Model Error Resolution Document

1. Originator: Carlos Jove-colon/David C. Sassani	2. Date: 02/26/2008	3. ERD No. ANL-EBS-MD-000045 ERD 01
4. Document Identifier: ANL-EBS-MD-000045 Rev 03		5. Document Title: In-Drift Precipitates/Salts Model

This Error Resolution Document (ANL-EBS-MD-000045 ERD 01) is for the model report *In-Drift Precipitates/Salts Model* (ANL-EBS-MD-000045 Rev 03) to correct errors reported by the Condition Reports listed below, or identified in the document during the corrective actions being performed.

Figure 7-23. Solubility and Deliquescence *RH* Predictions vs. Data for $\text{Ca}(\text{NO}_3)_2$

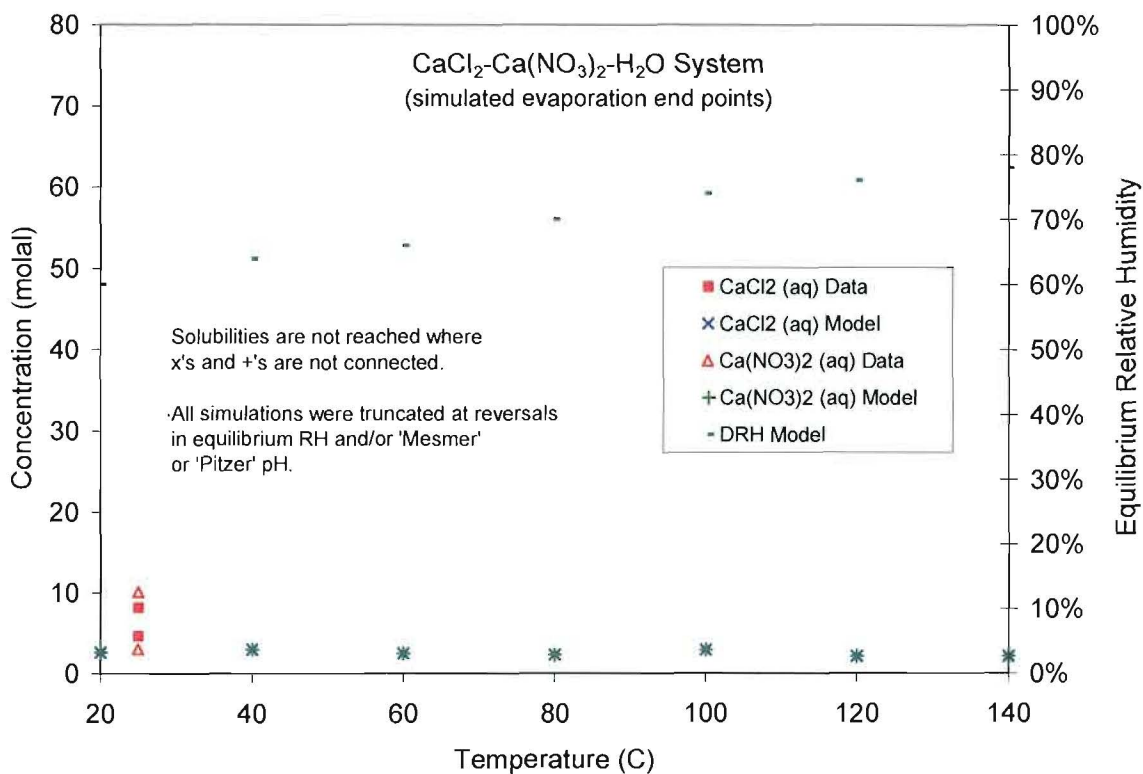
- Figure 7-23 cites file kcano32ev.xls instead of cano32ev.xls. This is a typographical error.

- The note below Figure 7-23 cites file kcano32ev.xls instead of cano32ev.xls. This is a typo. The correct file is now cited in the corrected figure (included below). Because the data did not change, this issue does not affect the report or its conclusions. This is corrected to read “cano32ev.xls” in the note under the Figure 7-23 as shown below.

Output DTN: MO0701EQ36IDPS.000, file: *Linke binary1.zip, cano32ev.xls*.

Figure 7-46. Model Predictions vs. Data for Ca-Cl-NO₃ Eutectic System

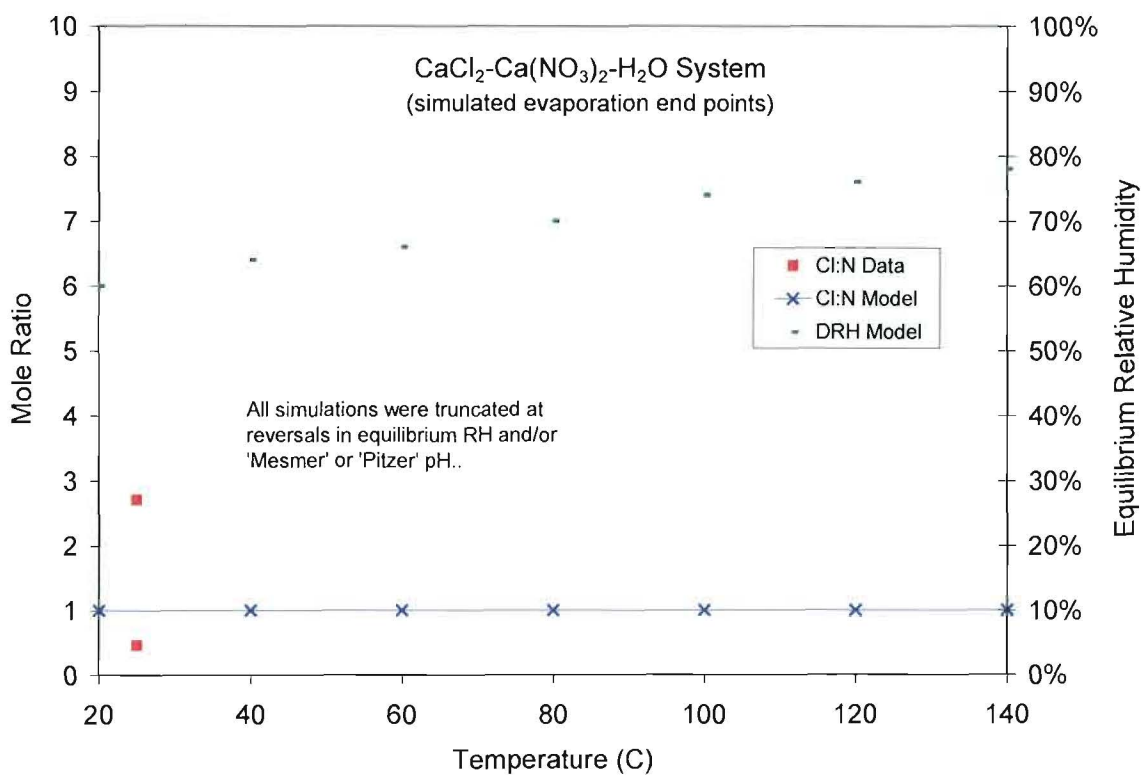
Note that CR 11044 (evaluated below) identifies an additional issue with the model results plotted for the Ca-Cl- NO_3 system in Figures 7-46 and 7-47. This resulted in an additional note being added to the figures and this is shown on the corrected Figure 7-47 in this section, but the correction is discussed in the next section on CR 11044. This additional issue does not affect the validation or limitations of the IDPS model, as explained in the resolution of CR 11044.

To address the above issues within the IDPS model report (ANL-EBS-MD-000045 REV 03), Figures 7-46 and 7-47 (ANL-EBS-MD-000045 REV 03) were modified with the results at the appropriate truncation points and to include a note that these simulations were to be truncated where a(w) reverses directions or where there is a reversal in pH. The updated figures are given above in the text, as well as in the DTN MO0701EQ36IDPS.000. Additionally, a specific note was added to the readme file for this DTN as listed below.

Truncating the Ca-Cl-NO₃ ternary system simulations at the point where a(w) reverses directions results in different end points on Figure 7-46, except for the simulation at 140°C, which showed no a(w) reversal but showed an unexpected inflection at a(w)~0.78 and a reversal in 'Pitzer' and 'Mesmer' pH values. However, even with these truncated results, there is very little difference in the model predictions at 20°C when compare to experimental data at 25°C. Thus, agreement between model simulations and experimental data is sufficient to satisfy model validation criteria and there is no impact on model validation or limitations. (The updated Figure 7-47 does not show any differences).

In the case of the simulation at 140°C, where there is no reversal in water activity, the run was truncated when there is a sharp reversal in 'Mesmer' or 'Pitzer' pH (excluding NBS). As noted previously, there is a strong correlation between reversals in the activity of water and sharp reversals in 'Mesmer' or 'Pitzer' pH for all these runs. Therefore, a reversal in 'Mesmer' or 'Pitzer' pH should also be considered as an indicator of the evaporation simulation yielding erroneous data beyond certain value of water activity. The resulting end-points from the simulations at low temperatures are expected to be a closer representation of the salt solubility given the abrupt termination of the higher temperature simulations at relatively large water activities. As a concluding remark, it should be emphasized that this condition does not affect the model validation or its limitations. The updated figures with new end-points and explanatory notes are given above.

Figure 7-47. Cl:NO₃ Mole Ratio Predictions vs. Data for Ca-Cl-NO₃ Eutectic System

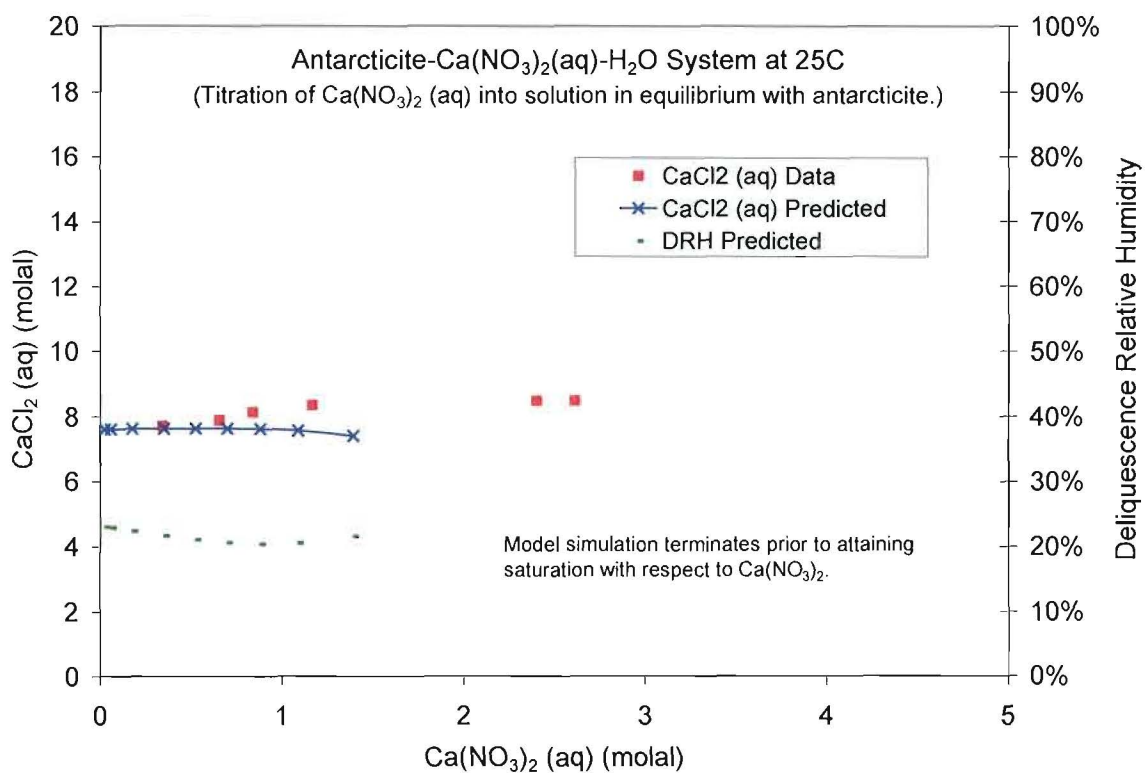
- Figure 7-47 cites file kcln91.xls instead of caclnv.xls. This is the wrong file from the DTN.
- Figures 7-48 through 7-51 have incorrect captions. The captions for 7-48 and 7-49 should have been switched with those for 7-50 and 7-51 (or the figures switched).
- Figures 7-48 and 7-49 include notes that say the model reaches saturation with respect to $\text{Ca}(\text{NO}_3)_2$ at 1.4 molal. These notes are incorrect. Instead, the model terminates at 1.4 molal prior to saturation with respect to this phase.
- Excel spreadsheets in MO0701EQ36IDPS.000 reference superseded DTN as input.
- Spreadsheet "cacln25.xls" tab "Data" contains a note "Note: The CaCl_2 value may be erroneous" This note comes off the source DTN (LL031106231032.007) but appears to be incorrectly applied as a general statement within the spreadsheet.

- The note below Figure 7-47 cites file kcln91.xls instead of cacln91.xls. This is the wrong file from the DTN; however, the correct file from the DTN can be discerned from the figure and the DTN readme file. The correction to the footnote of Figure 7-47 is shown below. The fix is replacing the file name ‘kcln91.xls’ with ‘cacln91.xls’. This does not affect the report or its conclusions. The correction to the footnote of Figure 7-47 is shown below.

Output DTN: MO0701EQ36IDPS.000, file: Linke ternary1.zip, caclev.xls.

Figure 7-48. CaCl_2 Solubility Predictions vs. Data as a Function of $\text{Ca}(\text{NO}_3)_2$ Concentration at 25°C

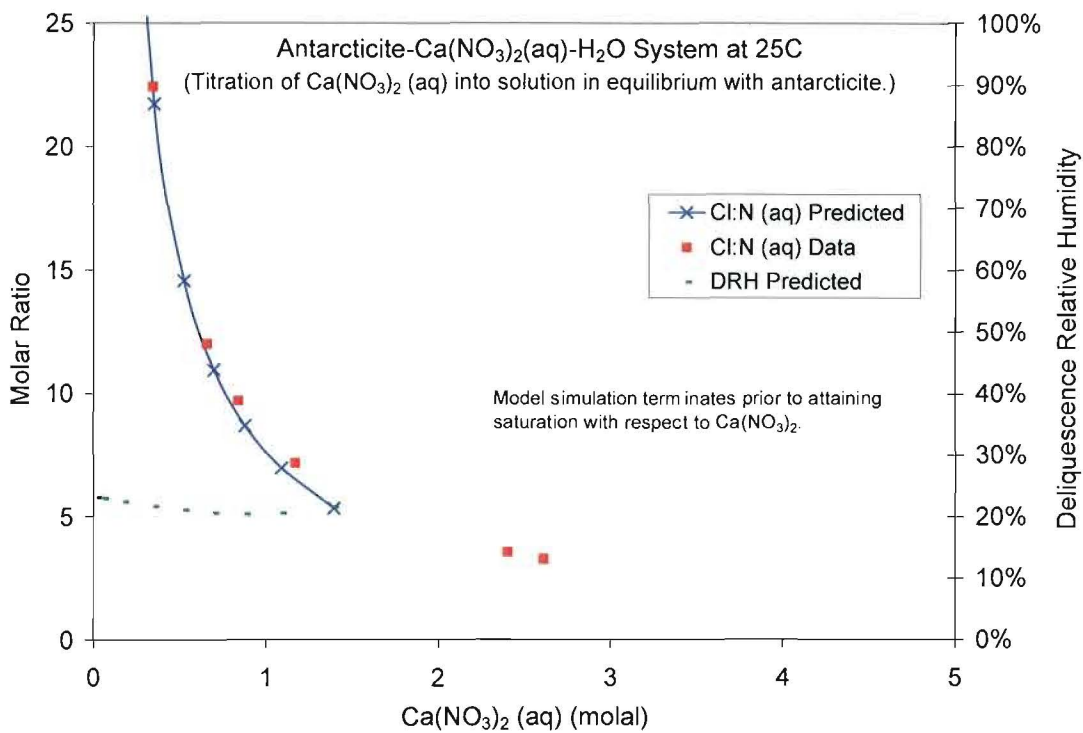
- Figures 7-48 through 7-51 have incorrect captions. The captions for 7-48 and 7-49 should have been switched with those for 7-50 and 7-51 (or the figures switched). This can be discerned from the descriptions in the figures themselves and can be confirmed by the sources listed. This error does not affect the report conclusions since premature termination of the run is acceptable in accord with validation purposes and validation criteria. The fix to switched captions for figures 7-48 through 7-51 is shown below.

- Figures 7-48 and 7-49 include notes that say the model reaches saturation with respect to $\text{Ca}(\text{NO}_3)_2$ at 1.4 molal. These notes are incorrect. Instead, the model terminates at 1.4 molal prior to saturation with respect to this phase. However, premature termination is acceptable for validation purposes (p. 7-8 ANL-EBS-MD-000045 REV 03). Model validation includes comparisons of experimental data to model results regardless of how the simulations terminate. As long as the differences between simulated end points and experimental data are within validation criteria (which they are in this case), validation criteria are met. Therefore, this does not affect the report or its conclusions. To correct this, the notes in Figures 7-48 and 7-49 stating the model reaches saturation with respect to $\text{Ca}(\text{NO}_3)_2$ at 1.4 molal have been removed, and the statements in these notes have been replaced with the following “Model run terminates prior to attaining saturation with respect to $\text{Ca}(\text{NO}_3)_2$ ”. The corrected Figures 7-48 and 7-49 are shown below and in the revision to DTN MO0701EQ36IDPS.000.

Figure 7-50. Ca(NO₃)₂ Solubility Predictions vs. Data as a Function of CaCl₂ Concentration at 25°C

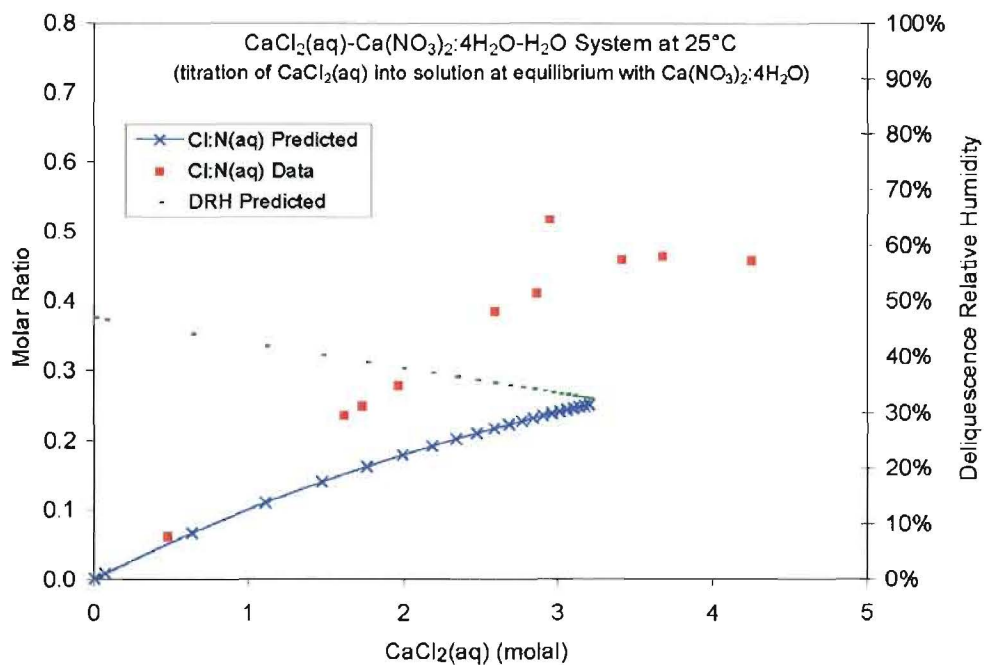
- i. The line segment connecting the symbols for the 120°C and 140°C results in Figure 7-5 should not be present because the solubility limit was not achieved in the 120°C result. This is a note error because a note in the figure states "solubility limit not reached where x's are not connected."
- ii. The note in Figure 7-24 that the solubility limit was not reached over the entire temperature range is wrong; it was reached at 140°C.
- iii. There should be a line segment connecting the symbols for the 20°C and 40°C results in Figure 7-40 to indicate saturation with respect to $\text{Ca}(\text{NO}_3)_2$ at 20°C and 40°C. The note in the figure should state that "Solubilities are not reached where symbols are not connected."
- iv. The source file for Figure 7-50 should be cacln25.xls.

4. The source file for Figure 7-50 should be "cacln25.xls". The caption in Figure 7-50 for the source spreadsheet file has been corrected to read "cacln25.xls" as shown below.

Output DTN: MO0701EQ36IDPS.000, file: *Linke ternary1.zip, cacln25.xls*.

Figure 7-5. Solubility and Deliquescence *RH* Predictions vs. Data for CaCl₂.

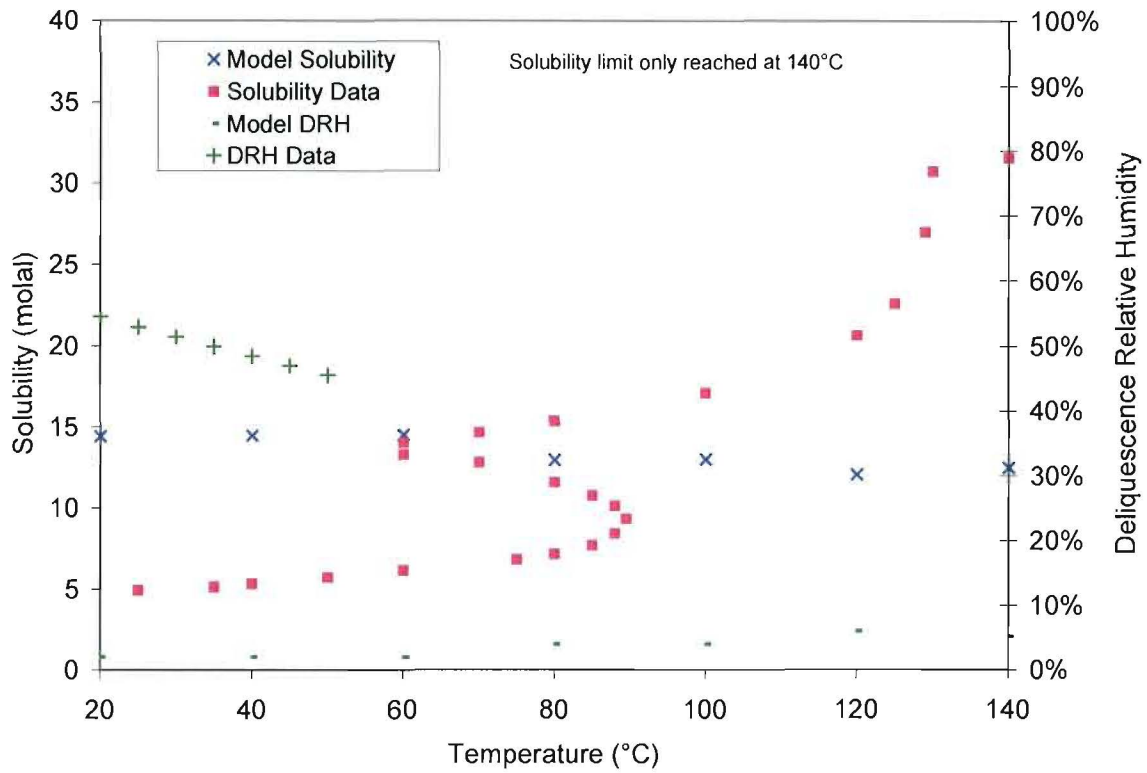
1. The line segment connecting the 120°C and 140°C results in Figure 7-5 should not be present because the solubility limit was not achieved in the 120°C result. This is a note error because a note in the figure states "Solubility limit not reached where x's are not connected." To correct this, the line segment connecting the symbols for the 120°C and 140°C results in Figure 7-5 has been removed consistent with the note in the figure about not reaching solubility limits. The corrected Figure 7-5 is shown below and in the revision to DTN MO0701EQ36IDPS.000.

Figure 7-24. Solubility and Deliquescence RH Predictions vs. Data for $Mg(NO_3)_2$.

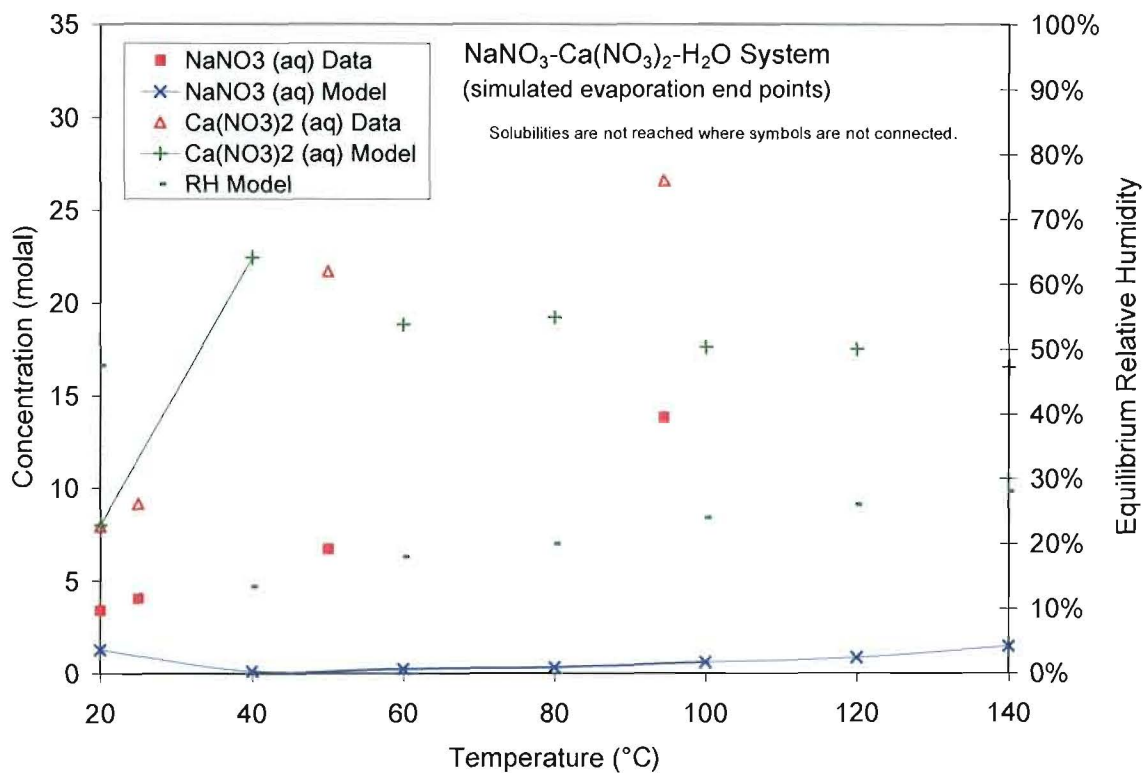
2. The note in Figure 7-24 that the solubility limit was not reached over the entire temperature range is wrong; it was reached at 140°C. The notation is corrected to read "Solubility limit only reached at 140°C". The corrected Figure 7-24 is shown below and in the revision to DTN MO0701EQ36IDPS.000.

Figure 6-4. Example Aqueous Composition Evaporation Predictions vs. RH

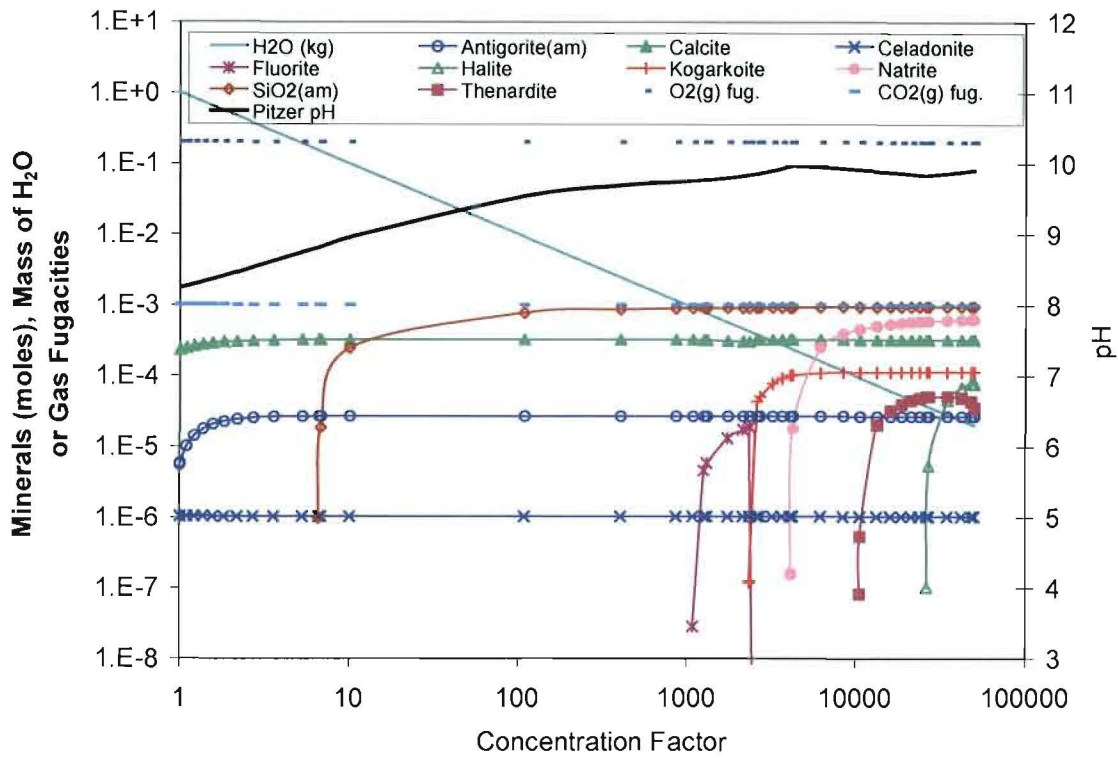
Issue #11: (1) Evaluation of this issue indicates that each figure in Section 6.7 (Figures 6-4 and Figures 6-7 in ANL-EBS-MD-000045, Rev. 03) does not exactly match the values in the cited DTN. Accurate figures are provided in the DTN in the files containing the calculations. These figures are for demonstration only and do not have any effect on model validation, limitations, uncertainty, or use in TSPA-LA.

(1) Figures 6-4 and 6-7 in Section 6.7 do not exactly match the data in the DTN but accurate figures can be found in the files in the DTN that contain the calculations. Therefore, this discrepancy does not impact the model results or the conclusions derived from them. The figures reflecting accurate representation of the data are already contained in DTN SN0611T0509206.006 and are shown below.

Figure 7-68. Predicted vs. Measured Concentrations for Synthetic J-13 Water Evaporation Experiments of Rosenberg et al. (1999 [DIRS 125338])

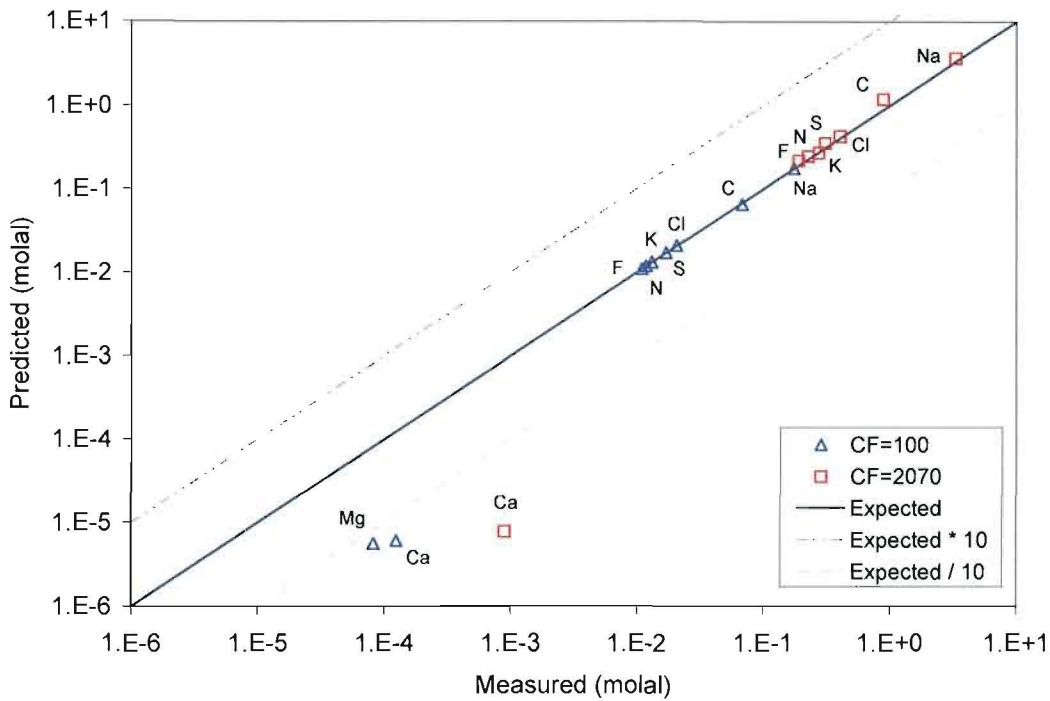
Issue #1: *Missing labels for data points in figures 7-68 and 7-72 in ANL-EBS-MD-000045 (REV 03).*

Evaluation: Per the CR description, traceability is sufficient given the relevant text explanation related to the significance of these figures in the report ANL-EBS-MD-000045 (REV 03). Also, the original figures are in DTN: SN0702T0509206.008, files ‘j13n1pitpH.xls’ and ‘j13b1v3.xls’, and include the missing labels for the data points. Moreover, the figures with labeled data points that are used in SAR section 2.3.5 were obtained directly from the DTN source because they are correct. Therefore, the corrected figures 7-68 and 7-72 are given below to replace those with missing labels in the report ANL-EBS-MD-000045 (REV 03).
